**Figure NC-3224.13(c)(6)(-a)-1
Inherent Reinforcement for Small End of Cone-Cylinder Junction**

Figure NC-3224.13(c)(6)(-b)-1
Values for Q for Small End of Cone-Cylinder Junction

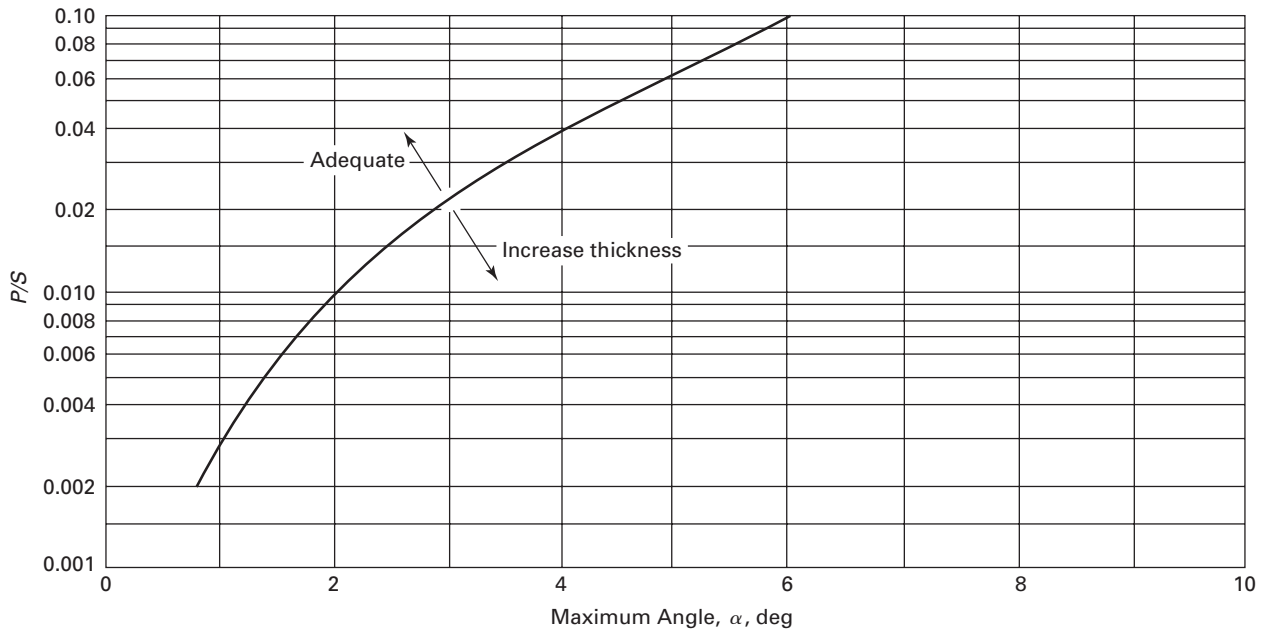
GENERAL NOTE: Curve governed by membrane stress intensity due to average circumferential tension stress and average radial compression stress limited by $1.1S_m$ at $0.25 \sqrt{\text{rad.} \times \text{thk.}}$ either side of junction.

change to " $0.5\sqrt{(\text{radius}) \times (t)}$ "

insert: ", where 'radius' is $(R_s + t_r / 2)$ on the cylinder side and $(R_s + t_r / 2) / \cos \alpha$ on the cone side"

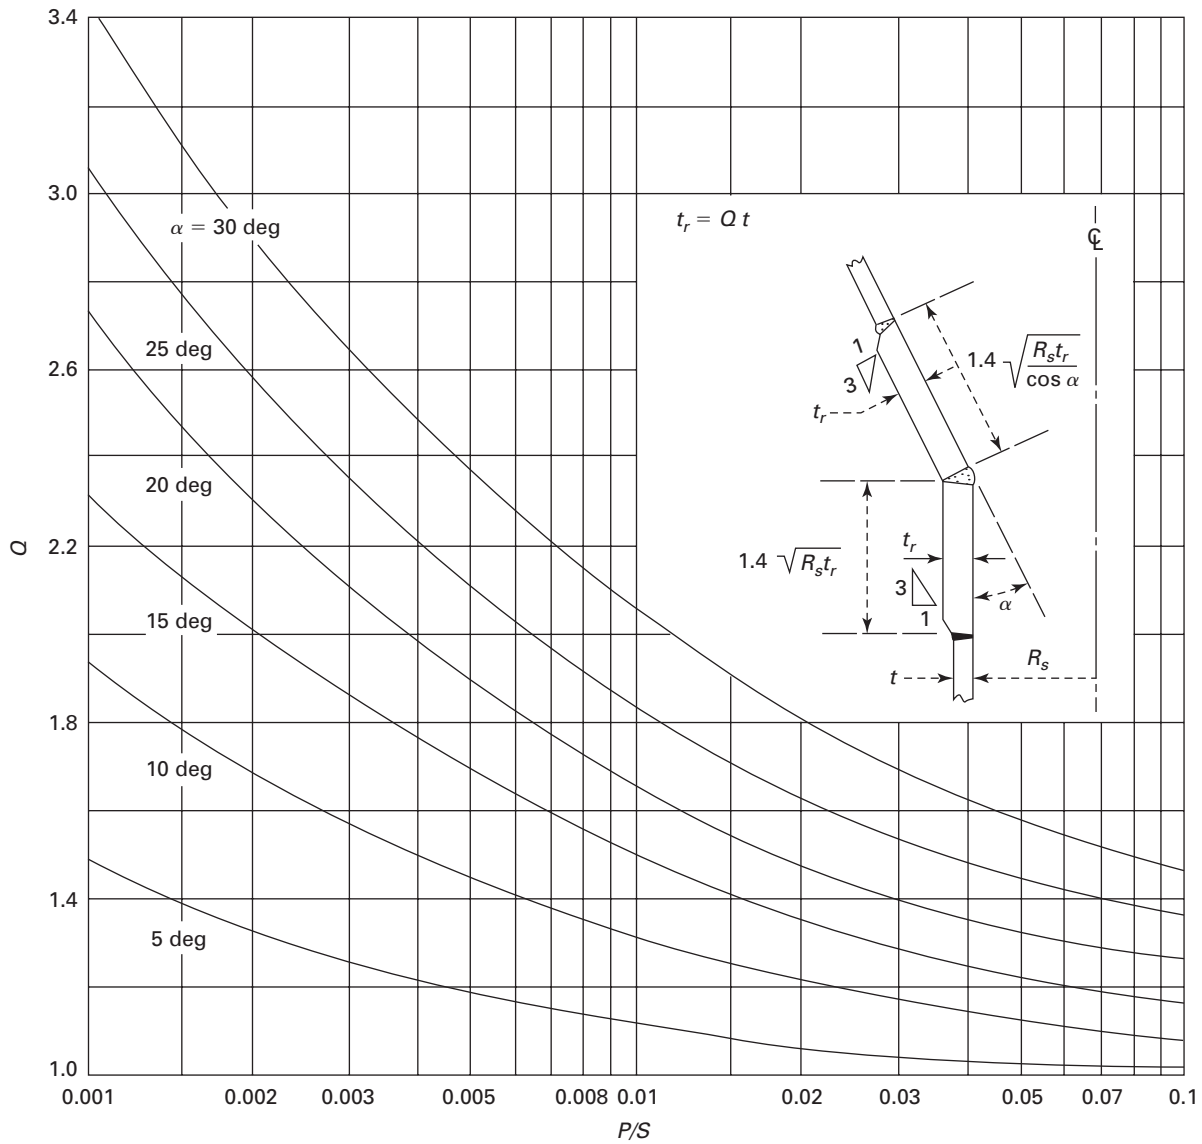
GENERAL NOTE: Curves governed by membrane stress intensity due to average circumferential tension stress and average radial compression stress limited by $1.1S_m$ at $0.25 \sqrt{\text{rad.} \times \text{thk.}}$ either side of junction.

change to " $0.5 \sqrt{(\text{radius}) \times (t)}$ "

insert: ", where 'radius' is $(R_s + t_r / 2)$ on the cylinder side and $(R_s + t_r / 2) / \cos \alpha$ on the cone side"
